MFN 06-191
Supplement 3

Subject: Response to Portion of RAI Letter No. 38 Related to ESBWR Design Certification Application - Seismic Category I Structures - RAI Numbers 3.8-3 S03, 3.8-6 S02, 3.8-13 S03, 3.8-14 S02, 3.8-18 S02, 3.8-20 S01, 3.8-25 S03, 3.8-26 S01, 3.8-27 S02, 3.8-41 S03, 3.8-46 S02, 3.8-48 S03, 3.8-51 S03, 3.8-56 S01, 3.8-64 S03, 3.8-87 S02, 3.8-90 S02, 3.8-91 S03 & 3.8-100 S02- Supplement 3

Response to Portion of RAI Letter No. 38

Seismic Category I Structures

Figure 3.8-2. Schematic of Reinforcements in RCCV Wall Around Equipment Hatch/Personnel Airlock Opening

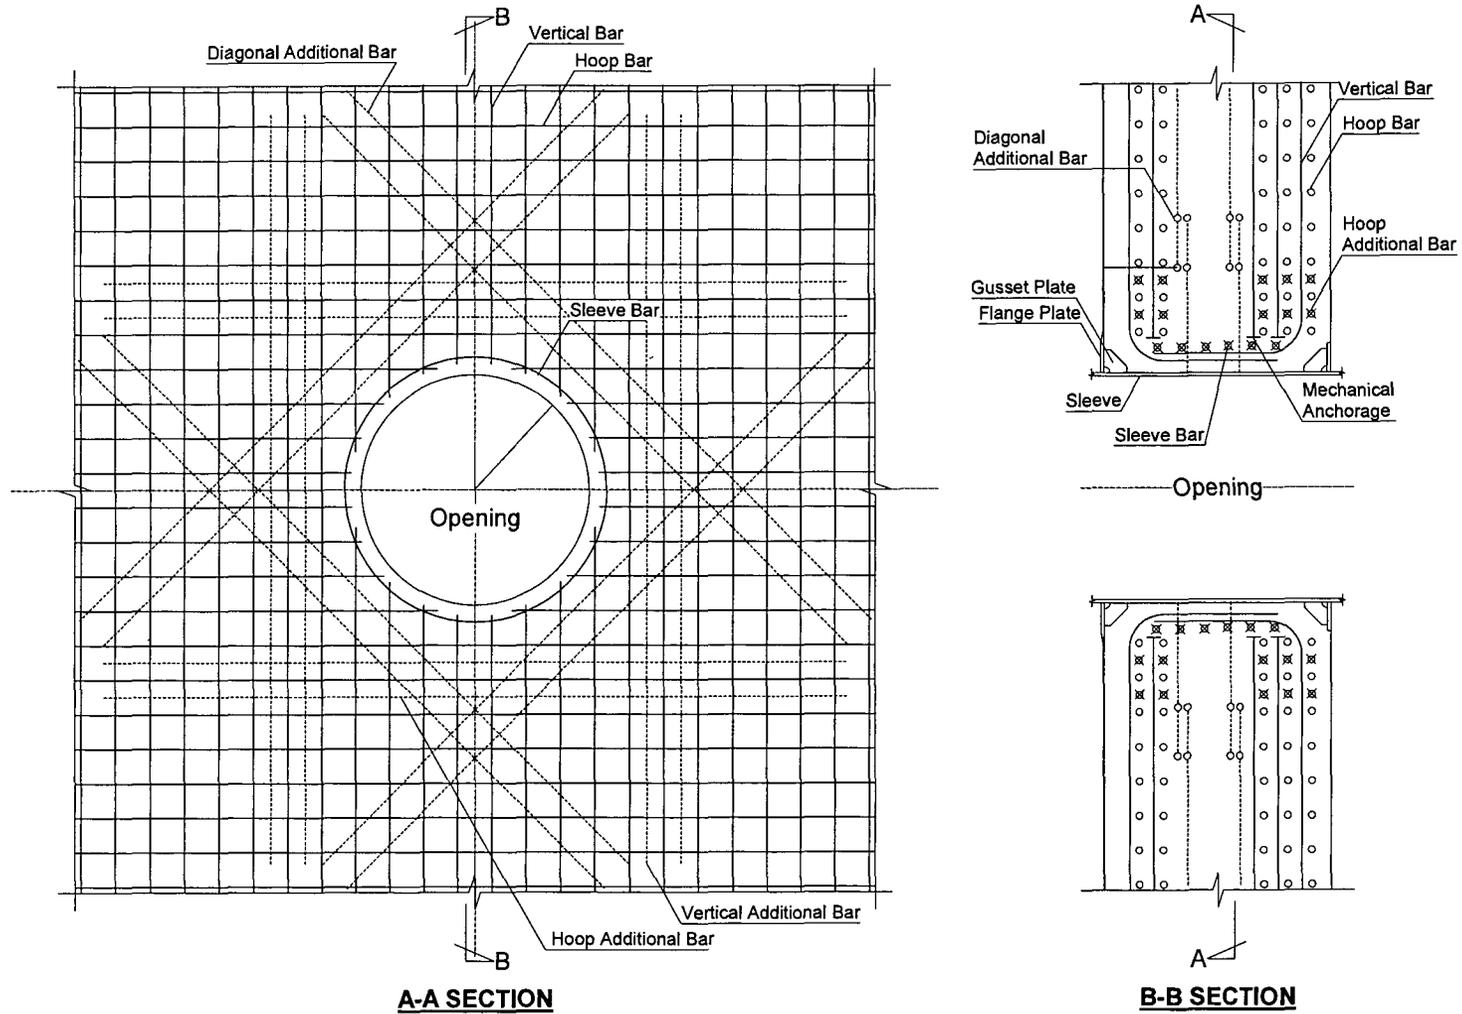
Include the description and sketches/details provided with the RAI response in the DCD.

Reinforcement is placed at major discontinuities in the wall, including the vicinity of the wall intersection with the foundation mat, the top slab and the suppression pool slab, around major piping penetrations, equipment hatches and personnel airlocks. Figure 3.8-2 shows a sketch of reinforcement in the RCCV wall around equipment hatches and personnel airlocks.

Figure 3G.1-55. Diaphragm Floor

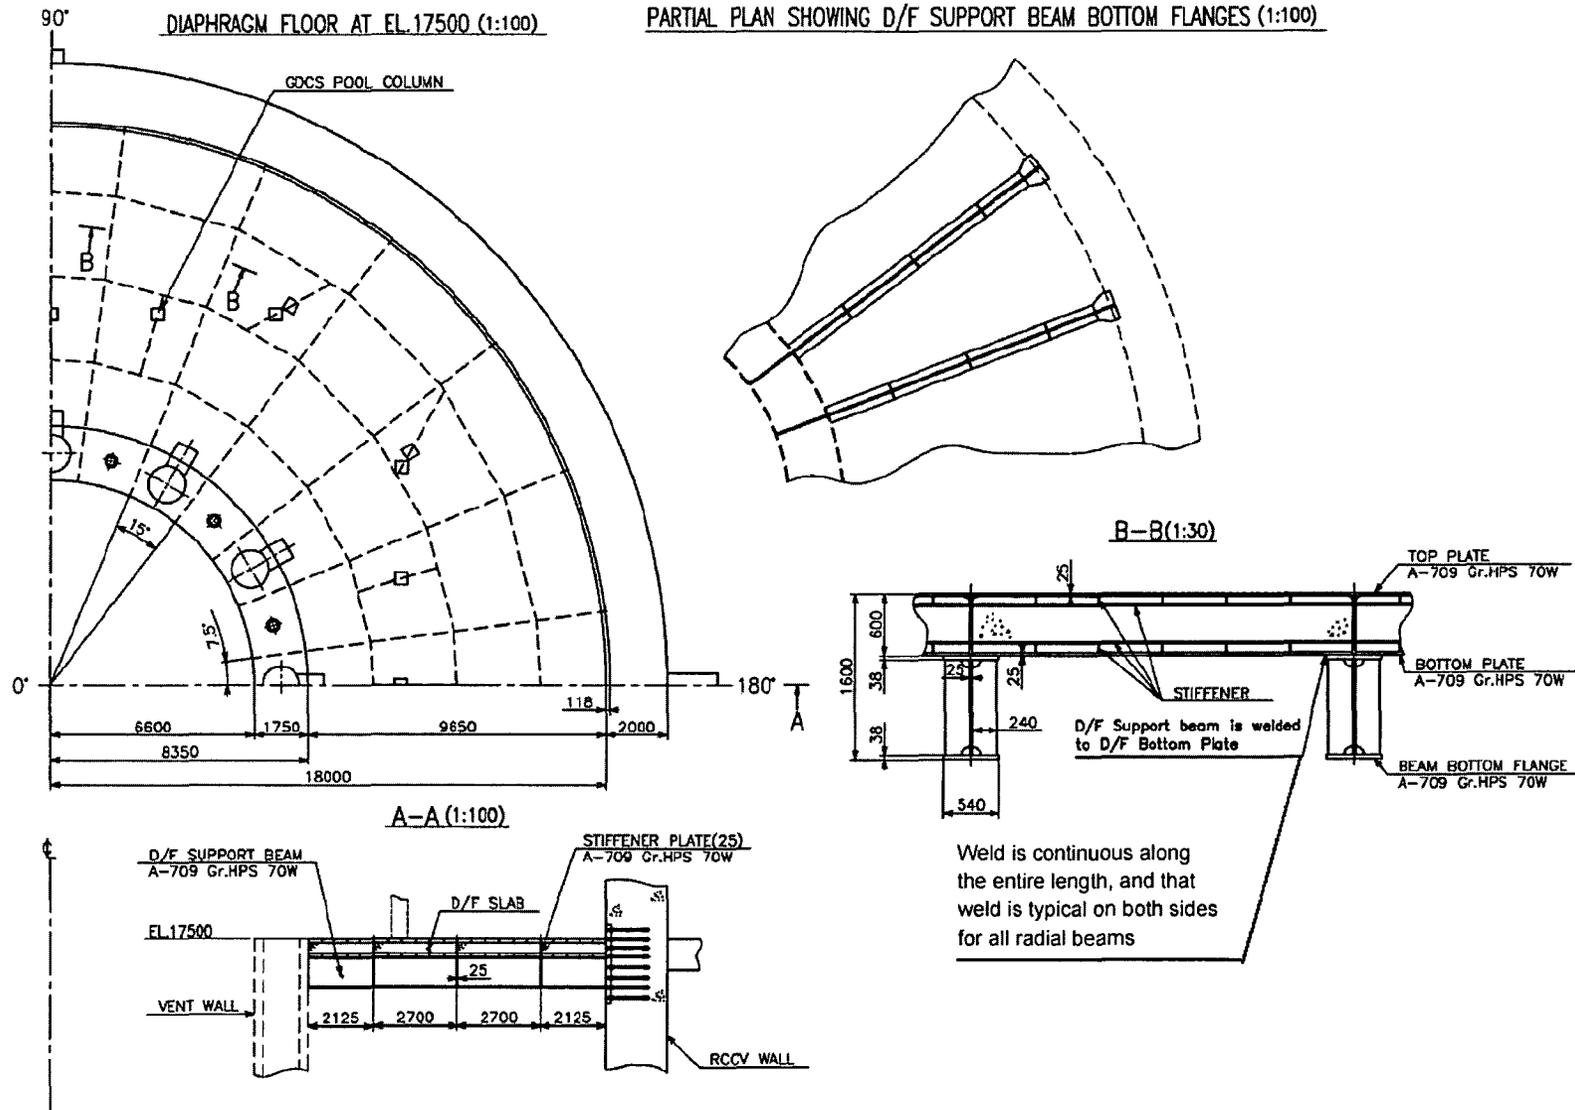
DCD Section 3.8.3.4.1 describes the analysis and design of the diaphragm floor and DCD figure 3G.1-55 provides a drawing of the diaphragm floor. From this information it is not clear whether the diaphragm floor is attached to the radial support beams in a manner that makes them respond as an integral member. Provide a description in DCD Section 3.8.3.4.1 and show in DCD Figure 3g.1-55 how the diaphragm floor and radial support beams are connected.

Further review of proposed markup of DCD Figure 3G.1-55 identified that there is insufficient information about the welded connection between the radial support beams and the diaphragm floor. The note should identify that the weld is continuous along the entire length, and that the weld is typical on both sides for all radial beams. GE needs to revise DCD Figure 3G.1-55 accordingly.

The radial support beams are welded to the diaphragm floor, so they form an integral structure. Markups of DCD Section 3.8.3.4.1 and DCD Figure 3G.1-55 were provided in MFN 06-191.

DCD Tier 2 Figure 3G.1-55 will be revised as shown below:
